COUNTY OF ALBEMARLE
PANTOPS PUBLIC SAFETY FACILITY
IFB # 2017-11223-20

NOVEMBER 15, 2016

ADDENDUM #3

This addendum herein supplements, modifies, changes, deletes from or adds to the original contract documents, dated October 28, 2016, for the Pantops Public Safety Facility, and is herein made part of the Contract Documents.

Design No. D780

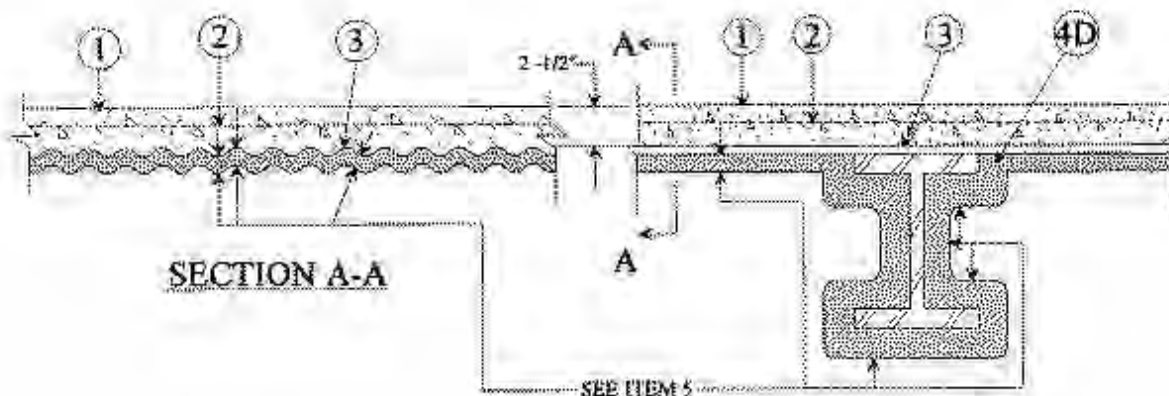
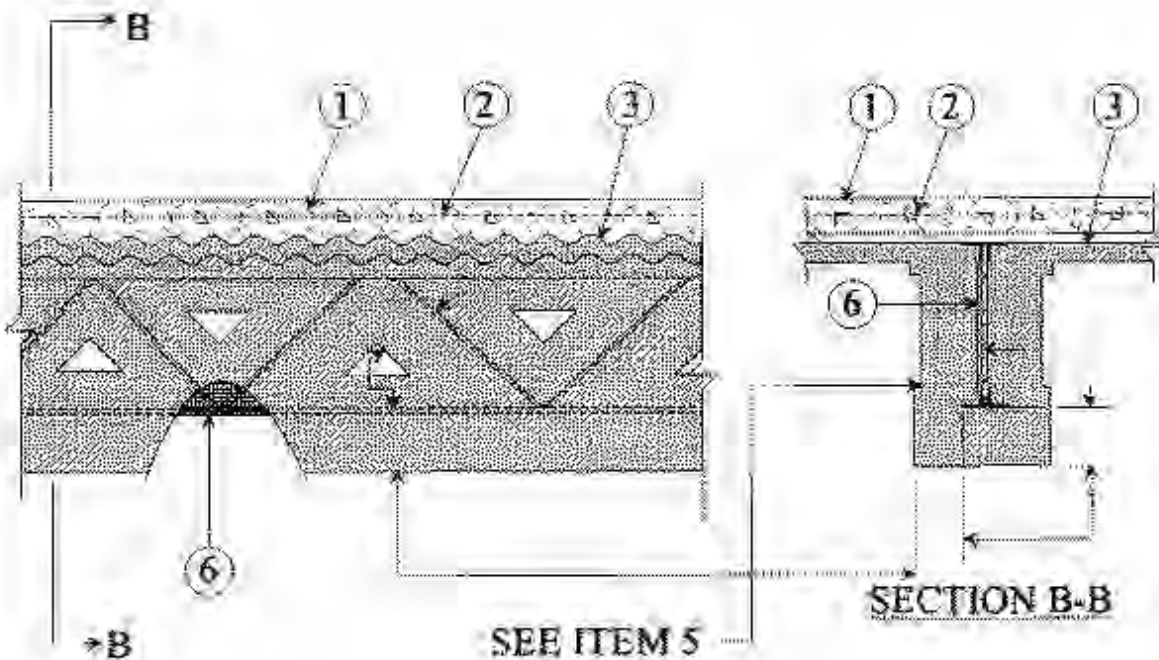
1. The total sheet count of 68 shown on the bid documents shall be revised to 67, typical all sheets.
2. Refer to the attached UL Design No. D780 for the 1 hour rated horizontal assembly referenced on sheets G-002 and A-101.

SK-1

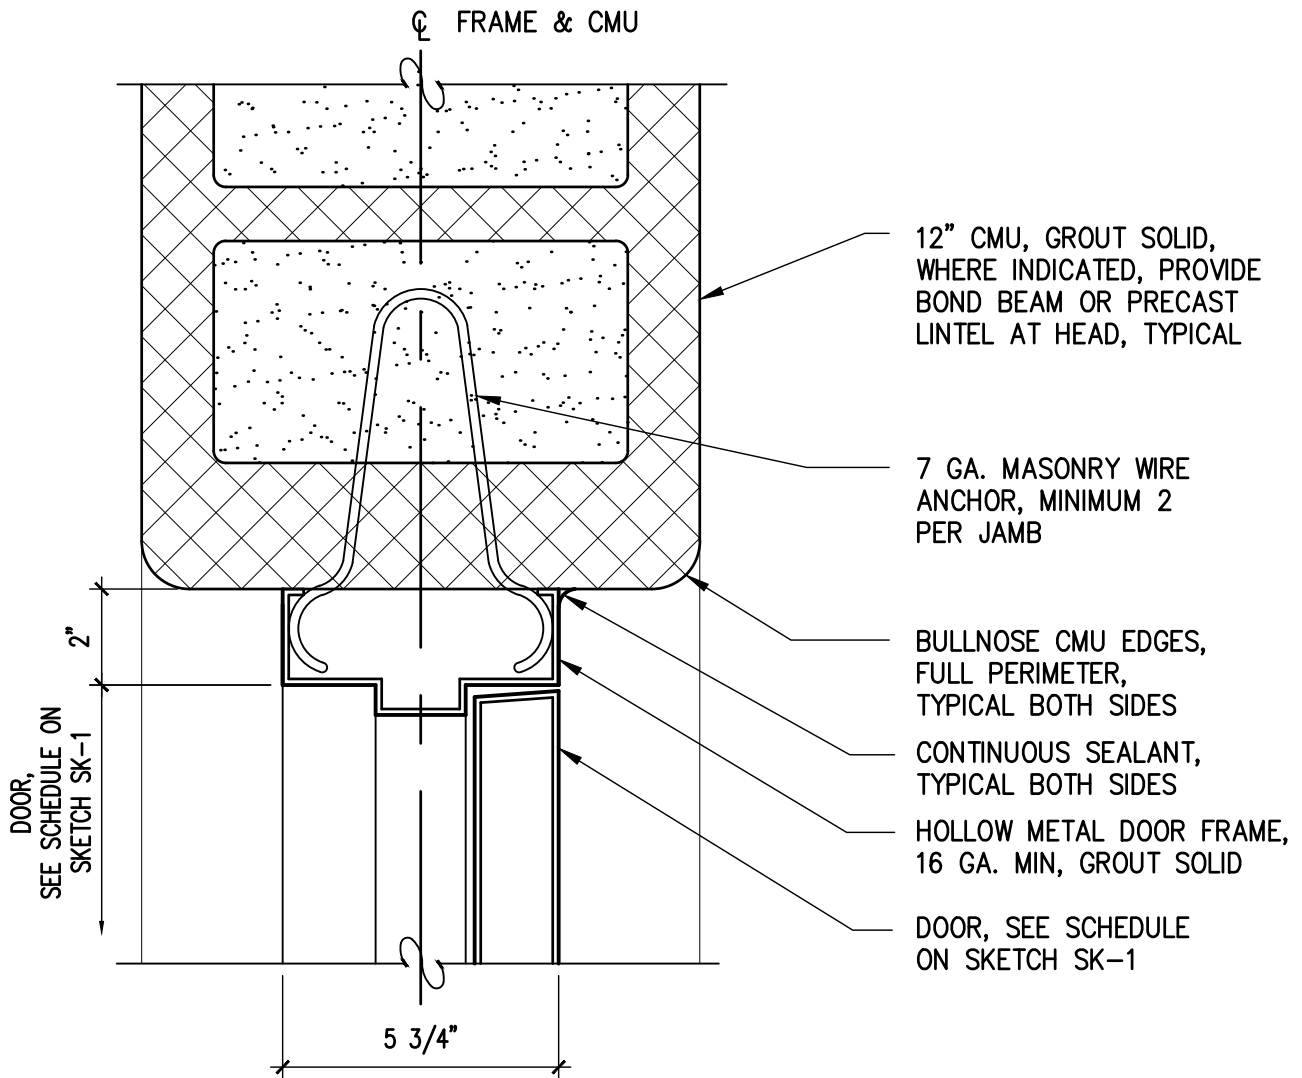
3. Provide a hollow metal attic access door and frame and associated door hardware located on the mechanical platform. Refer to the attached sketches SK-1, SK-2, and SK-3 for additional information.

REFER TO DOOR ELEVATIONS ON SHEET A-602 FOR ELEV 'B'. DOOR 200C SHALL BE 20 MINUTE RATED DOOR, FRAME, AND HARDWARE. DOOR HARDWARE FOR DOOR 200C SHALL BE AS FOLLOWS:

- 2 EA BUTT HINGES
- 1 EA MORTISE LEVER LOCKSET (STOREROOM)
- 1 EA CLOSER
- 1 SET DOOR SILENCERS
- 1 SET WEATHERSTRIPPING
- 1 EA KICKPLATE
- 1 EA THRESHOLD

SK-4

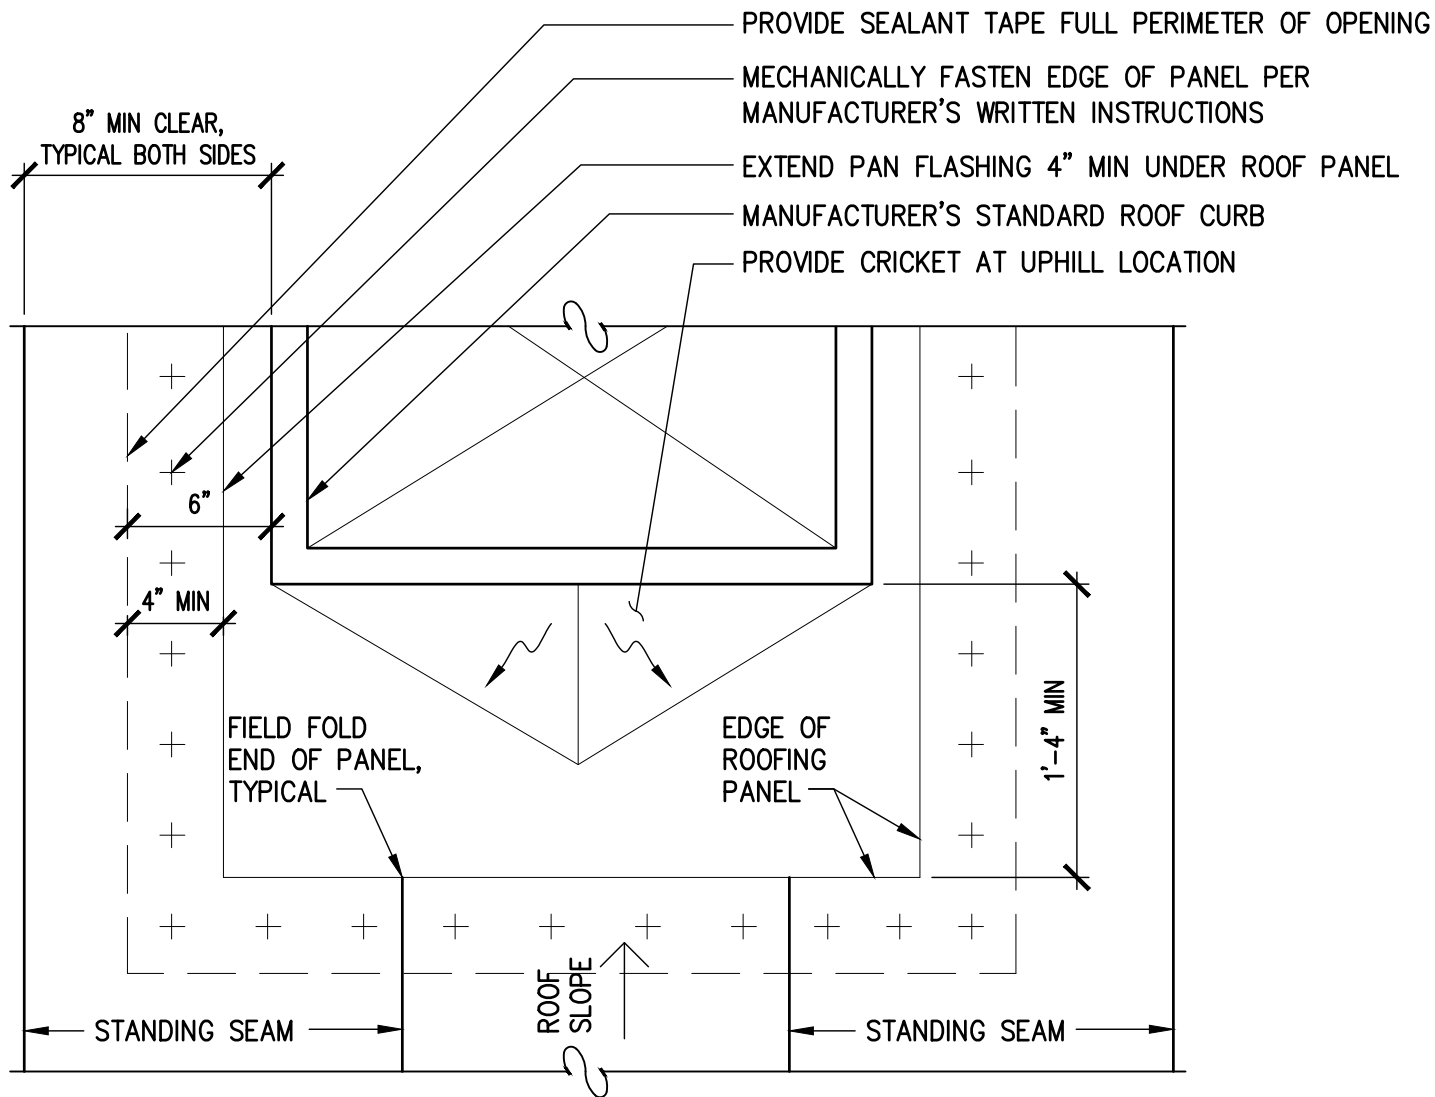
4. Refer to the mechanical drawings for information on the gravity vent on the maintenance building roof not identified on the roof plan on sheet A-103. Refer to attached sketch SK-7 for a roofing detail of the gravity vent (base bid). Refer to the attached sketches SK-4 and 5 for roofing details of the gravity vent on the maintenance building roof (additive bid item 6).

SK-6

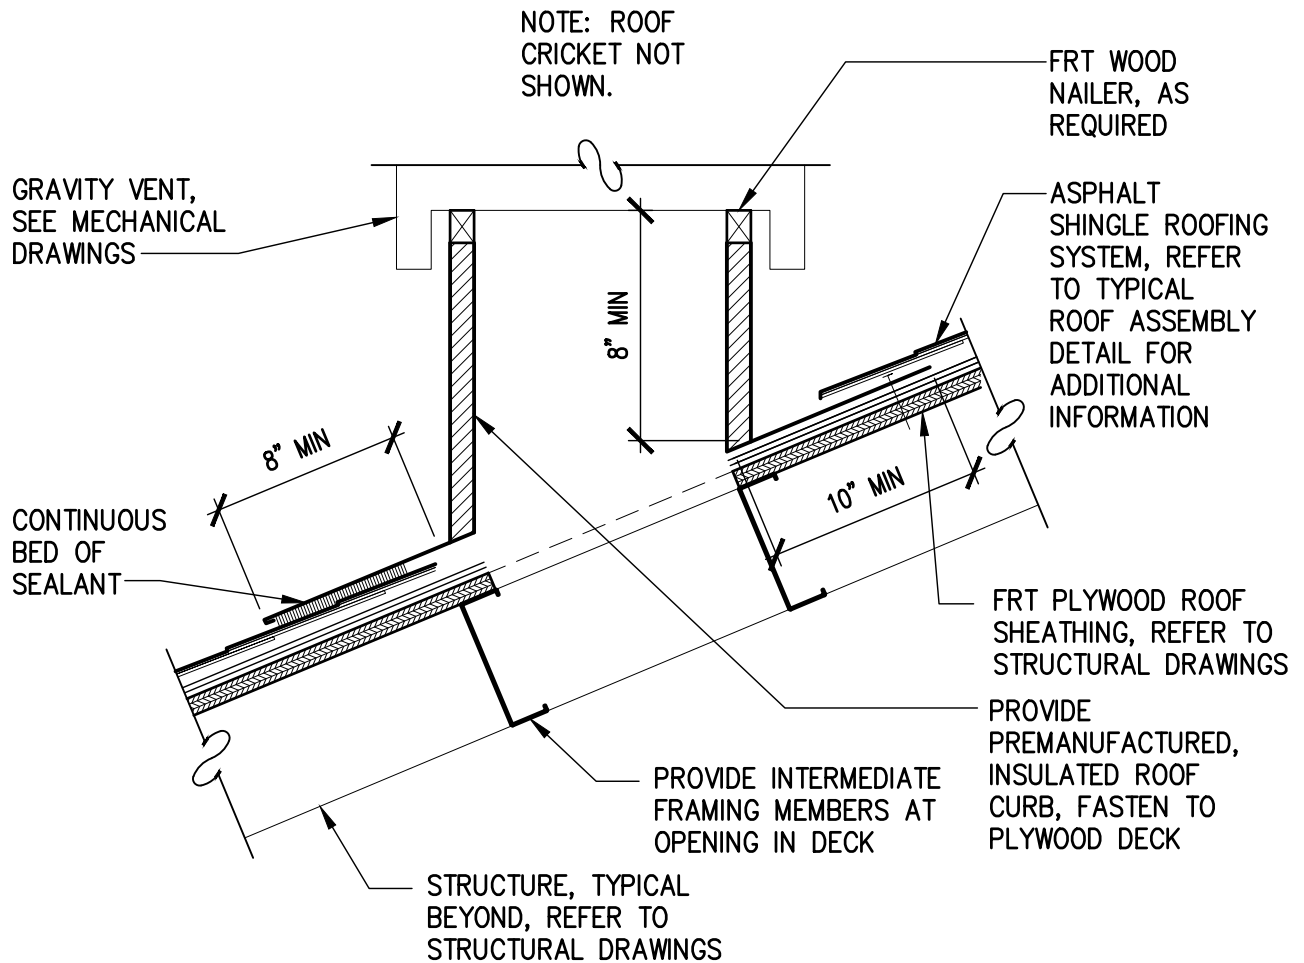
5. The two (2) closely-grouped vent-through-roof penetrations in the corner of the maintenance building roof on sheet A-103 shall be identified as gas heater exhaust vents. Refer to the attached sketch SK-6 for a roofing detail of the exhaust vent (base bid). Refer to the attached sketch SK-8 for a roofing detail of the exhaust vent (additive bid item 6).
